Architect's Supplemental Instructions

Architect's ASI No: 050

Project:
Webster University
Interdisciplinary Science
Building

Date Issued: 02/16/2017

LEVEL 01 AREA A FLOOR PLAN - MECHANICAL

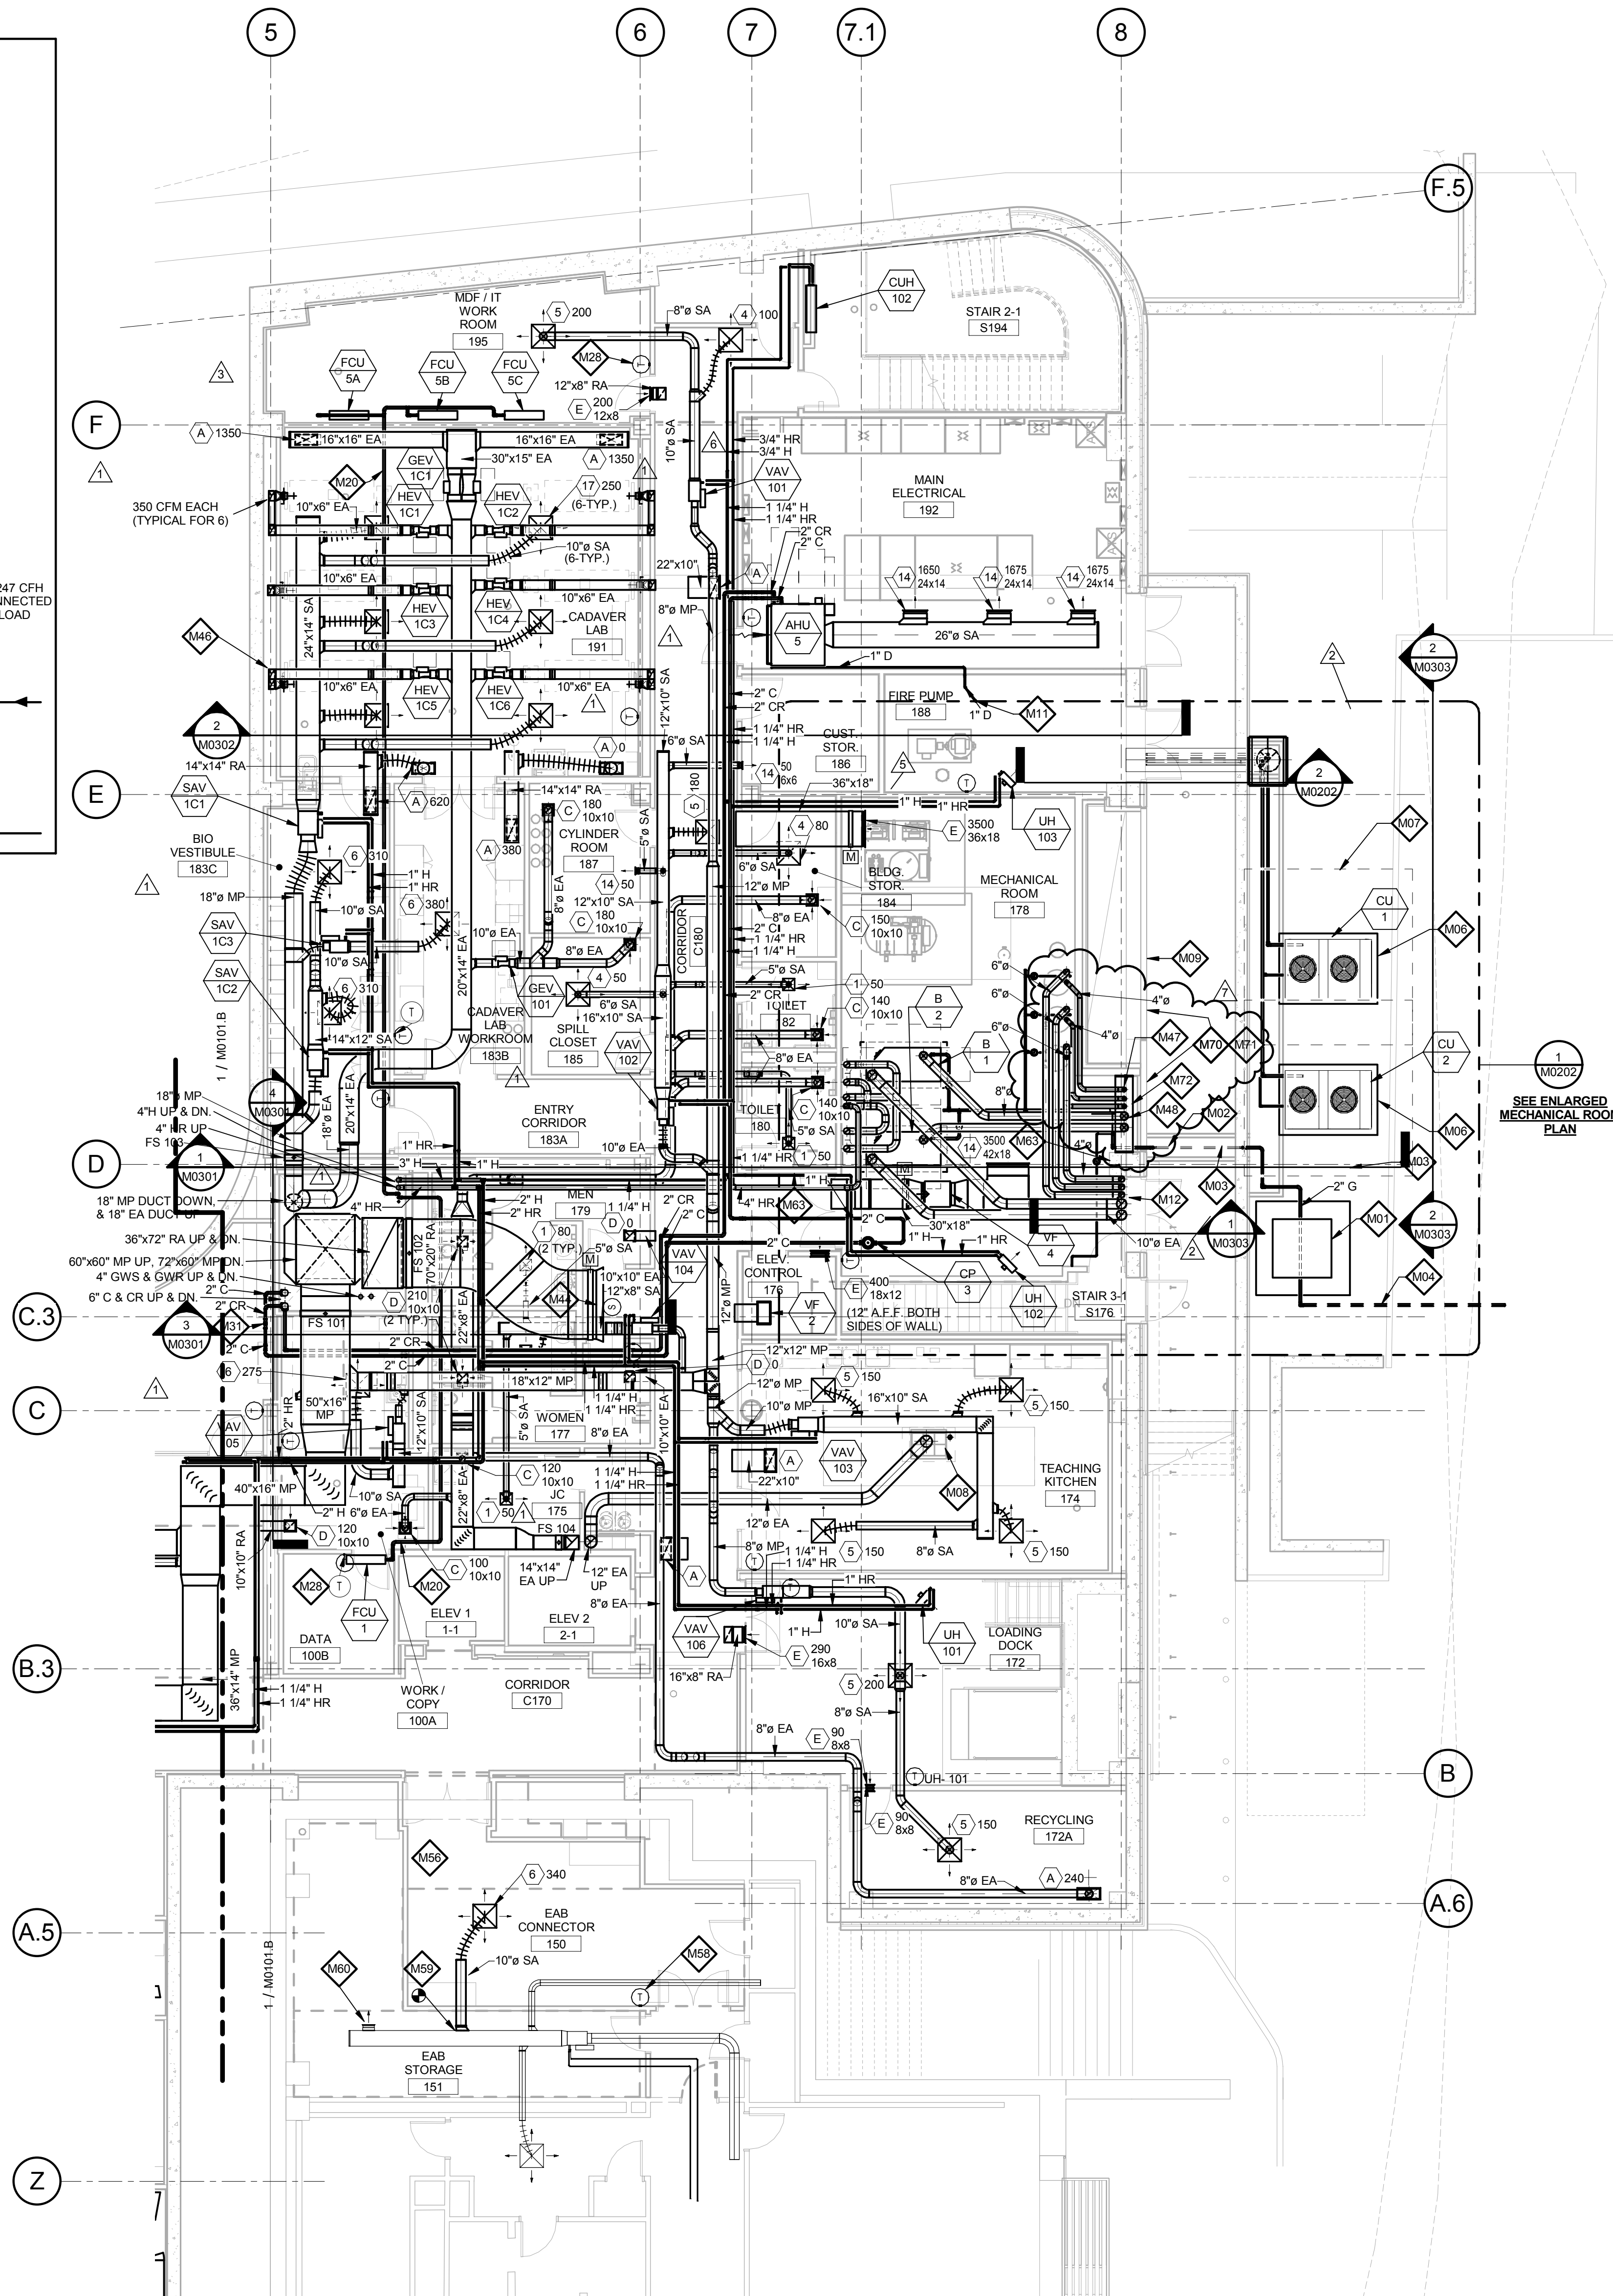
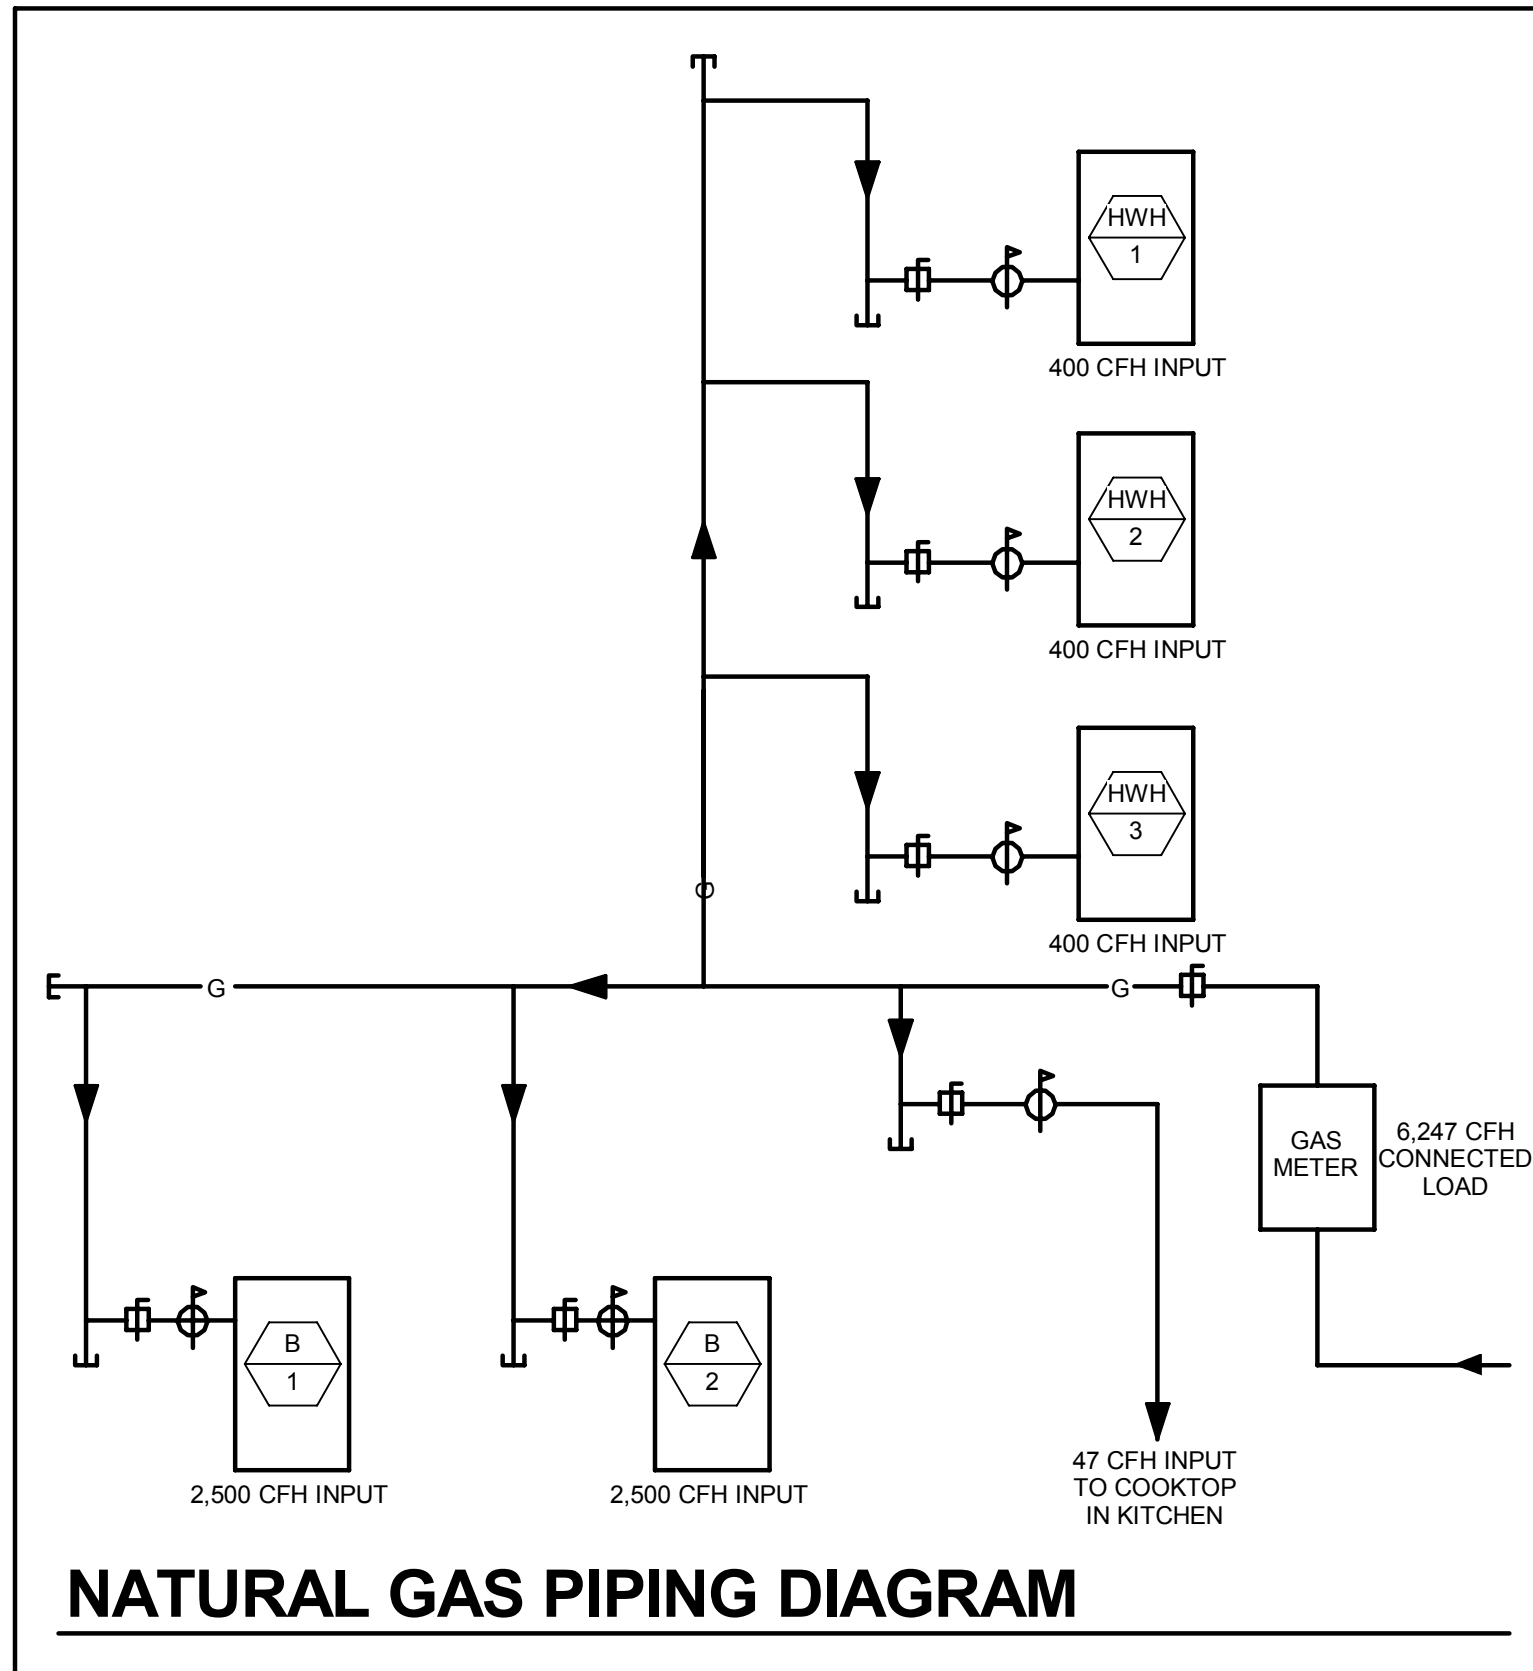
SHEET M0101.A

- Revised boiler and domestic water heater combustion air inlet connections at louver. Louver was previously modified on Architectural plans issued for Addendum 1-9.
- Modify Keyed Note #47
- Modify Keyed Note #48
- Add Keyed Note #70
- Add Keyed Note #71
- Add Keyed Note #72

- M47** CONNECT DOMESTIC WATER HEATER COMBUSTION AIR DUCTS TO TOP OF PLENUM BOX AT LOUVER.
- M48** CONNECT HEATING HOT WATER BOILER COMBUSTION AIR DUCTS TO TOP OF PLENUM BOX AT LOUVER.

- M70** REFER TO ARCHITECTURAL PLANS FOR ADDITIONAL LOUVER INFORMATION.
- M71** BLANK OFF ALL UNUSED PORTIONS OF LOUVER WITH INSULATED METAL PANEL PAINTED BLACK BEHIND LOUVER.

- M72** PROVIDE 78"x18" INSULATED PLENUM BOX AT LOUVER FOR COMBUSTION AIR INTAKES. SLOPE BOTTOM OF PLENUM PER DETAIL ON SHEET M0501.

**LEVEL 02 AREA A FLOOR
PLAN - MECHANICAL**

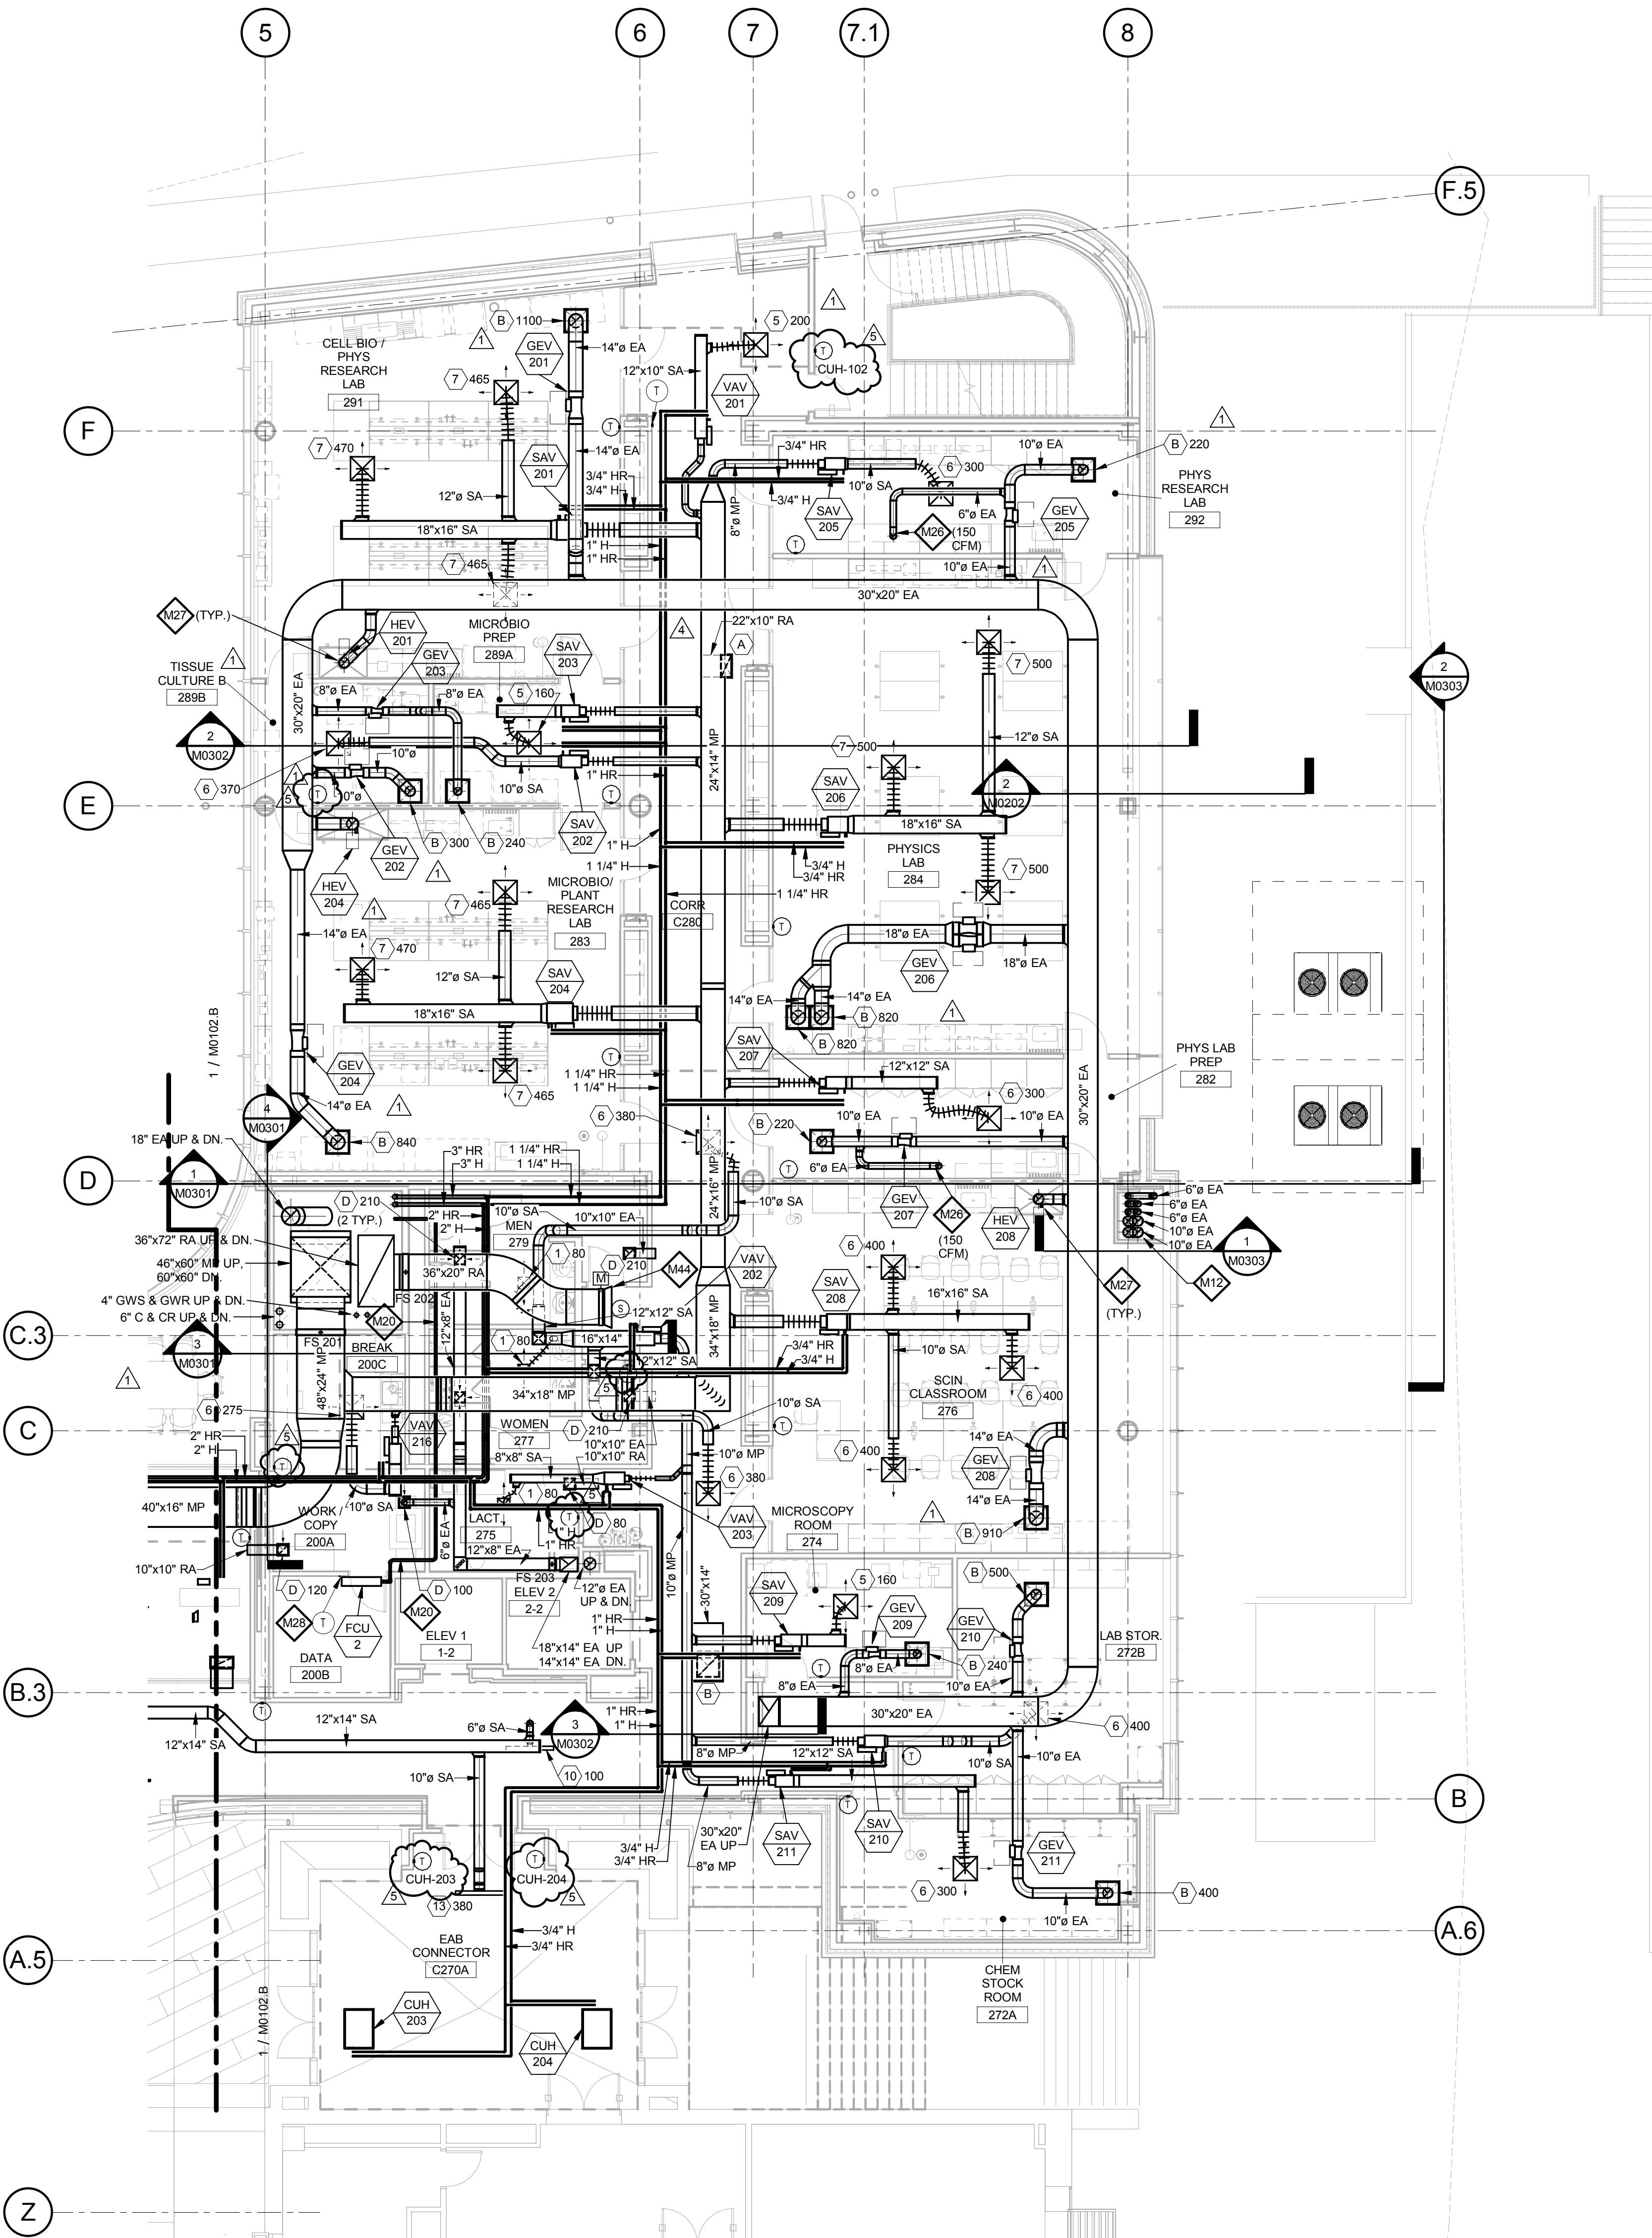
SHEET M0102.A

- Modify thermostat locations.
